General Service Bulletin

HCOM-SB-85

35-60 Ton Helical Rotary Compressor Motor Terminal Retrofit

Figure 1. Description of Motor Terminal Insulator Retrofit

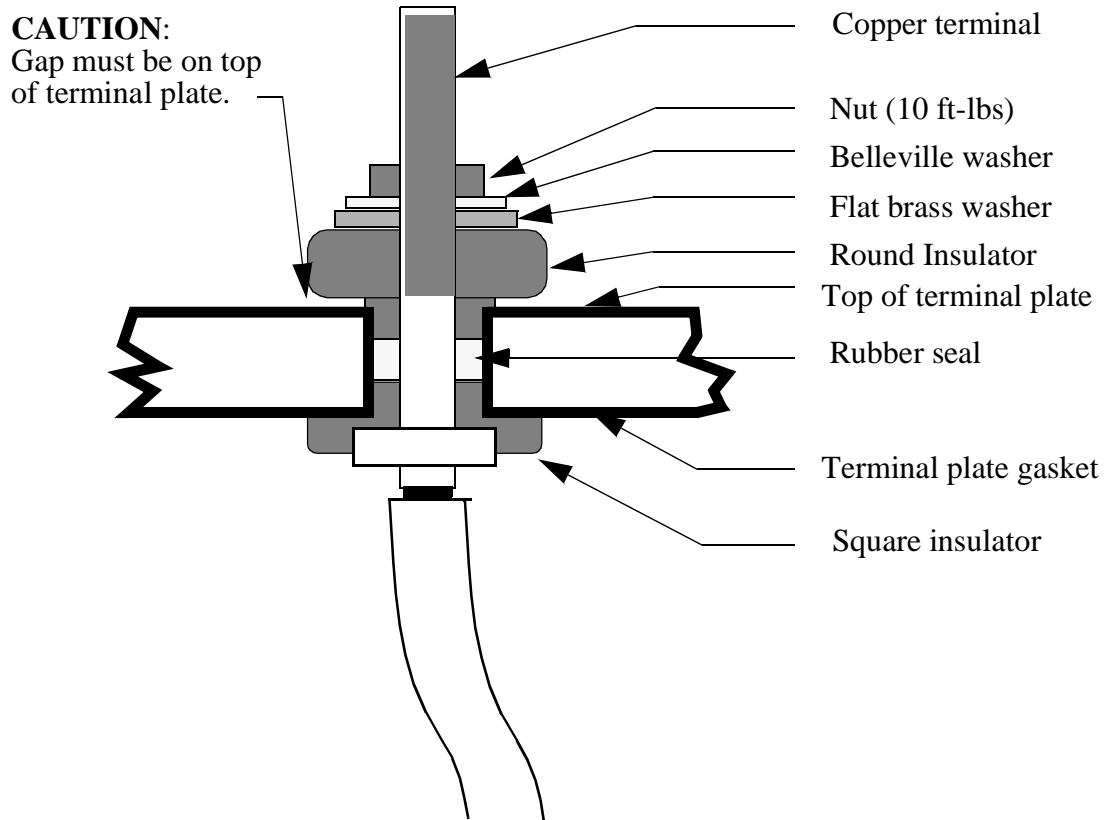
The original insulators used on the 35-60 ton helical rotor compressor motor terminals may leak due to slight variations in the terminal plate. Rather than re-designing the terminal plate, the motor terminal stud insulators were re-designed to be more tolerant of variations in the terminal plate.

The original insulators were also installed with steel nuts and washers. If the compressor is located in an environment with high humidity the steel nuts and washers will rust. The rust can travel down the terminal and across the insulator. This path can cause the compressor to short to the terminal plate.

As of July 14, 1996, the compressors are manufactured with the new insulators, as well as, brass nuts and washers. If the compressor terminals develop a leak follow the procedures below "Terminal Replacement". If the compressor has shorted follow the procedures below "Compressor Checkout". If the terminals are developing rust follow the procedures under "Terminal Corrosion".

5. Remove the terminal plate.
6. Inspect components for scratches, etc. that may cause a leak.
7. Remove lower insulator.
8. Begin reassembly by replacing lower insulators

- (green) with the square black insulator making sure the terminal post is seated in the insulator.
9. Replace o-rings with the rubber seal.
10. Oil and install new terminal plate gasket.
11. Carefully push terminals through the terminal plate.

12. Install upper insulator (round, black).
13. Place flat brass washer on top of the upper insulator.
14. Place belleville washer on top of the flat brass washer such that the outside edges of the belleville touch the flat washer.
15. Hand tighten the nut. Do not exceed 10 ft.-lb. on the nut. Refer to Figure 1 for the assembly of the new insulators.
16. Reconnect the spade connectors for the motor temperature sensors. Follow the color coding of the sensors.
17. Install the terminal plate on the compressor with the 12 mounting bolts. Follow the torquing sequence as shown in Figure 2.
18. Torque the terminal plate mounting bolts to 40 ft.-lb.
19. Torque the terminal stud nuts to 10 ft.-lb.
